Type III Development and Environmental Review Staff Report and Recommendation

Project Name: HOCKINSON MIDDLE SCHOOL

Case Numbers: CUP2015-00006; PSR2015-00035; EVR2015-00034;
WET2015-00023; BLA2015-00054

Request: Conditional Use and Site Plan Review approval for the construction of a new middle school located on roughly 25 acres in the RC-1 zone district

- Proposed Site Plan
- Category III Wetland Map

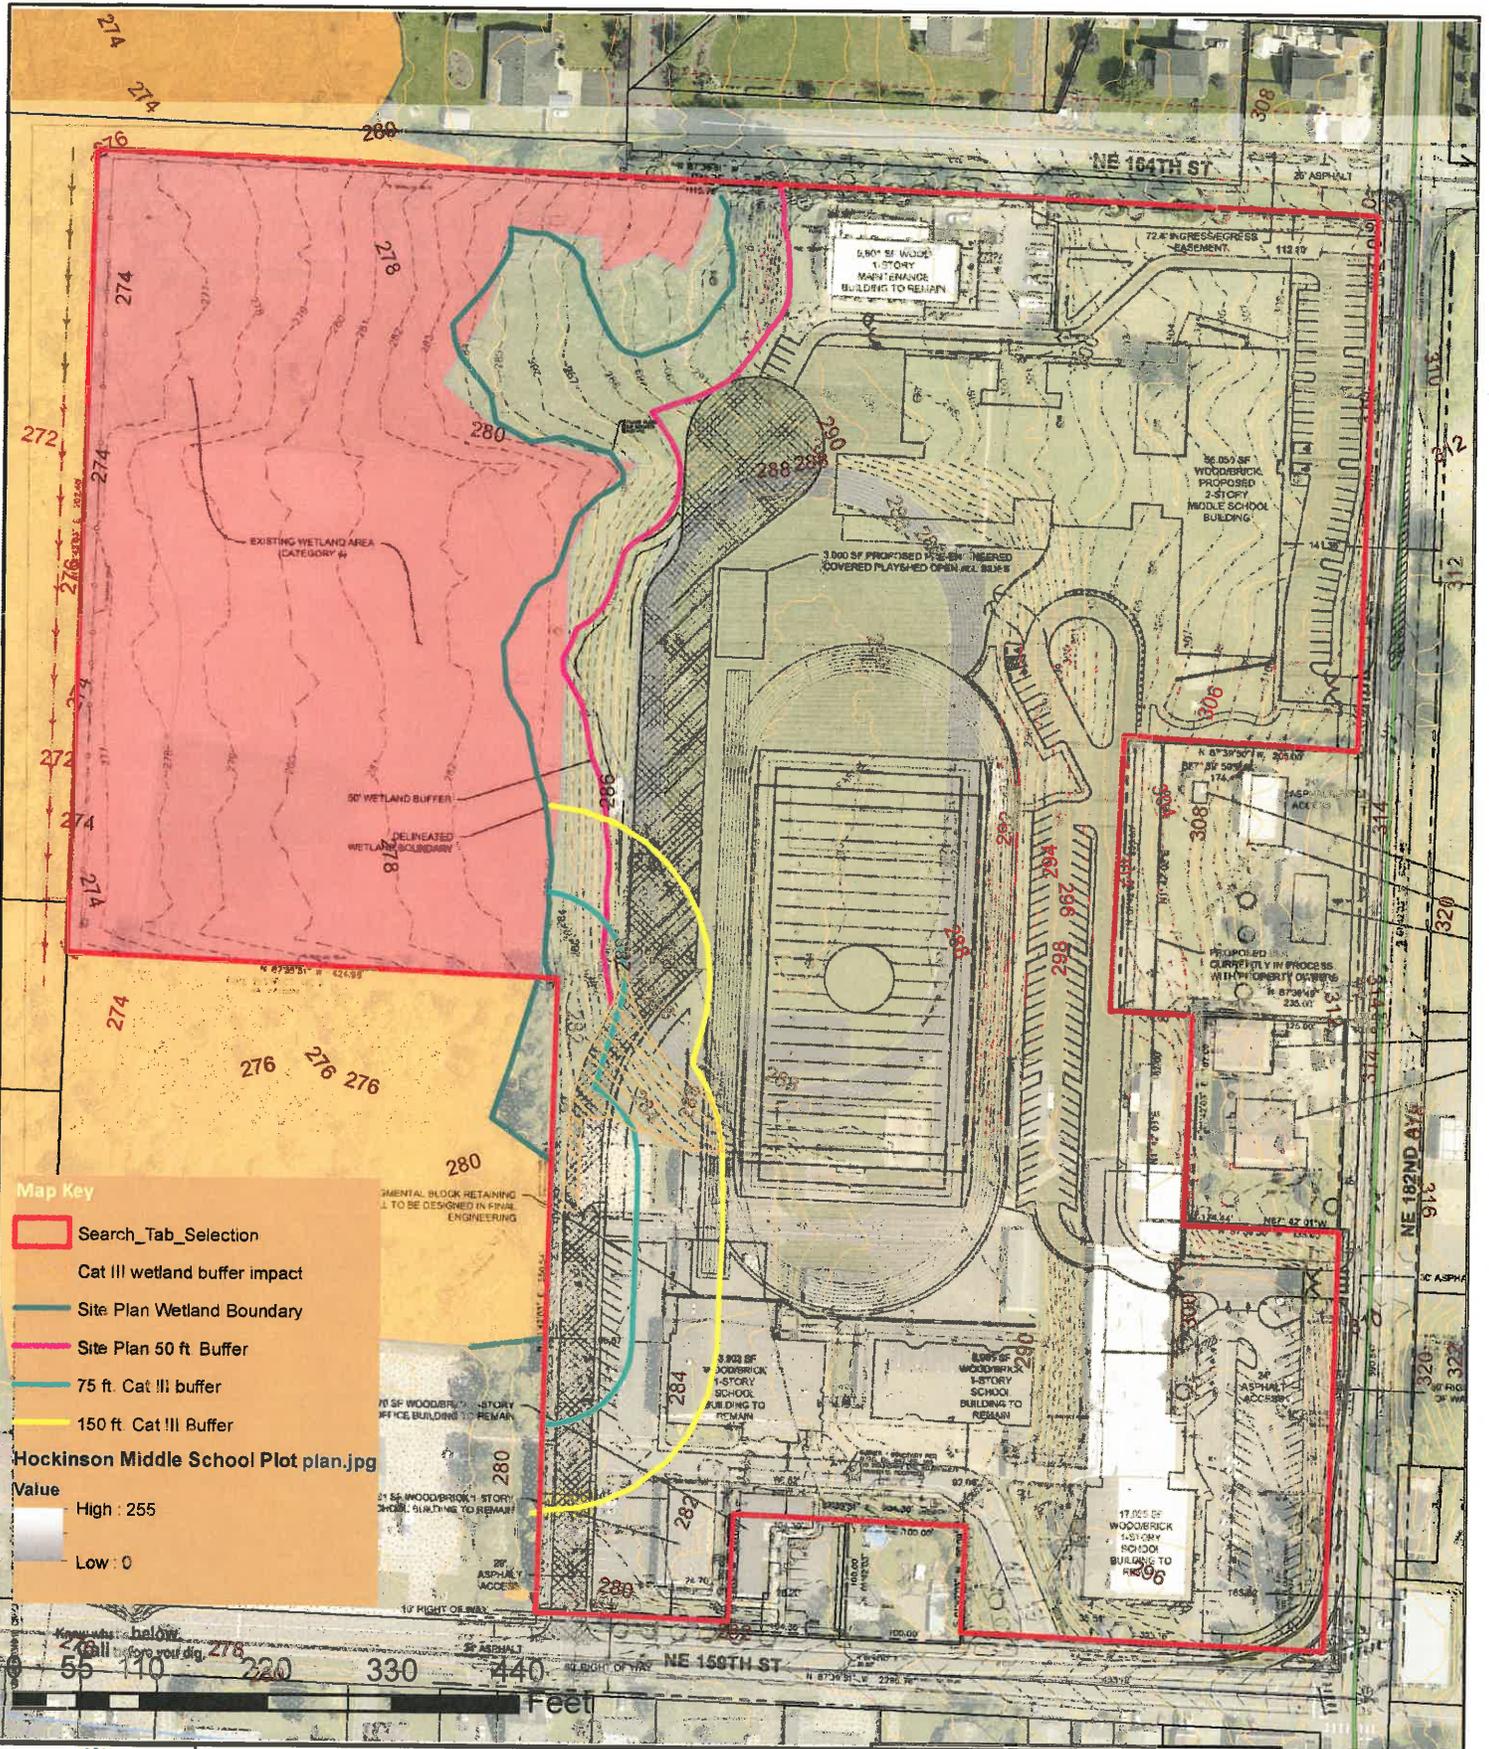
Approximately ten thousand four hundred (10,400) square feet of permanent Category III wetland buffer impact will result from the construction of the proposed access road and isolated wetland buffer (see attached map). County staff shall require that the applicant provide a mitigation plan which accounts for approximately seven thousand four hundred and twenty five (7425) square feet of Category III wetland buffer impact at a 1:1 ratio and two thousand nine hundred and seventy five (2975) square feet of indirect wetland impact (within the low intensity use buffer) at an 8:1 ratio utilizing native vegetation (as indicated in the conditions) within the category IV wetland.

No mitigation plan was provided by the applicant for impacts to the Category III wetland buffer. The applicant shall include a planting plan (including numbers, sizes, and types of species to be planted), performance standards for five (5) years of maintenance and monitoring, a schedule for release or reports, adaptive management plans, any contingency plans financial assurances for both the construction and maintenance of the site and site protection instrumentation. There is sufficient space on the parcel to accomplish the mitigation requirements. Any plants which have died in excess of these percentages shall be replaced, with maintenance and monitoring continuing.

The applicant must show that impacts to the buffer and wetland are minimized (if possible), and that buffer functions, as they pertain to protection of the adjacent wetland and its functions, are replaced.(40.450.040 (C) (5) (a) (b). Minimizing impact to the wetland buffer could consist of moving the road to the east as to not incur indirect wetland impacts and planting the area to the west of the road or a bio filter to protect the wetland from any potential runoff from the buildings and roadway.

- A-18 Final Wetland Permit approval shall be required (Construction Plan):
- a. The applicant shall clearly indicate how hydrology for the Category IV and the Category III wetlands to the west of proposed project will be maintained.

- b. The applicant shall provide an updated mitigation plan for impacts to the Category III wetland buffer.
 - c. The applicant shall provide financial assurances for the construction of the mitigation and five (5) years of maintenance and monitoring.

- d. The Final Construction plan shall show locations of the outer extent of the wetland buffers for marking in the field. Markings shall be installed prior to construction and maintained throughout the duration of construction
